Title	Mack Chassis - FSB 284 - 068, Exhaust Particulate Sensor, Repair (2016 Vehicles)
-------	--

This Field Service Bulletin replaces FSB 284-068 dated 11.2018

Exhaust Particulate Sensor, Repair
2016 Models
CXU, CHU, GU

FSB 284-068, Exhaust Particulate Sensor, Repair (2016 Vehicles)

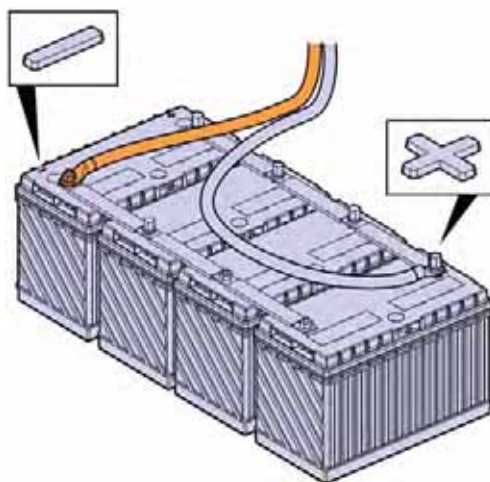
- 11 Install the new PM sensor and module.

Note: Align the tab on the sensor with the slot.

Note: Do not use any lubricant of any kind on the PM sensor threads.

- 12 Torque the sensor to 35 +/- 5 Nm (26 +/- 4 Ft lb)
- 13 Install the sensor module.
- 14 Torque the nuts to
M6: 10 +/- 5 Nm (88 +/- 3 in lb)
M8: 24 +/- 4 Nm (17.1 +/- 3 ft lb)
- 15 Install the wire ties and clamps.
